**METROPOLITAN GOVERNMENT  
OF NASHVILLE AND DAVIDSON COUNTY**

**Minutes  
Of the  
Metropolitan Planning Commission**

*4/24/2008*

Example as suggested in Condition 1 text

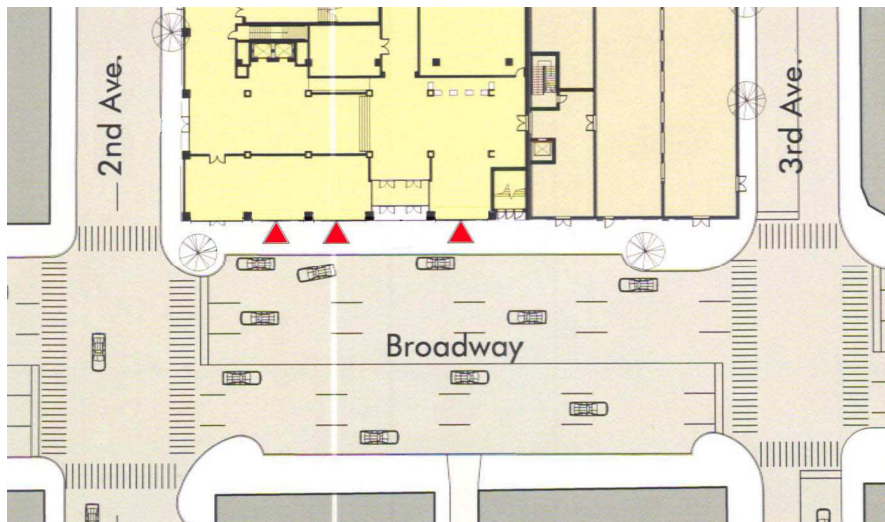
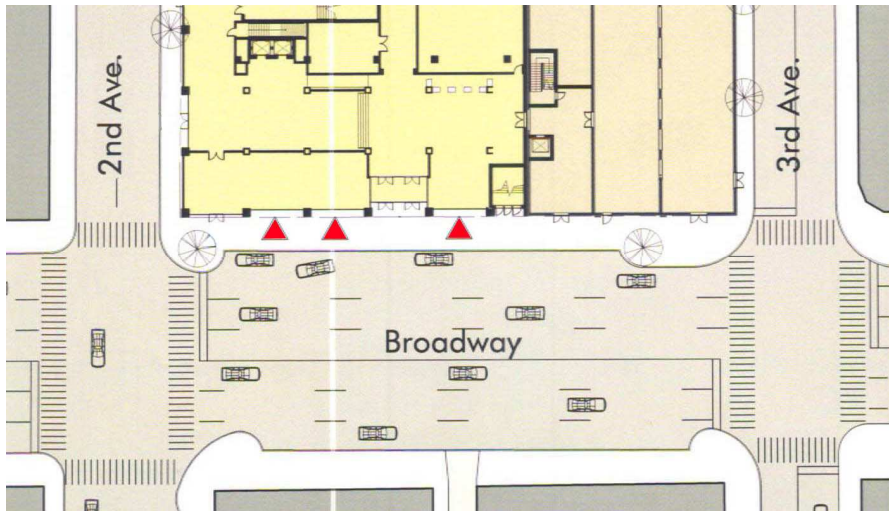
1. The Broadway street façade shall be pulled up to the property line with recesses and step-backs along the building edge only for entrance and design transition from old-buildings-to-new purposes. The street elevation of the new structure shall be in the same plane as the original 'historic' facades, in order to be consistent with other buildings in the historic streetscape. Although similar in form and materials, the composition and details of the new façade are to be more simplified. The design transition from old-buildings-to-new shall be reinforced by the narrow recessed connector.
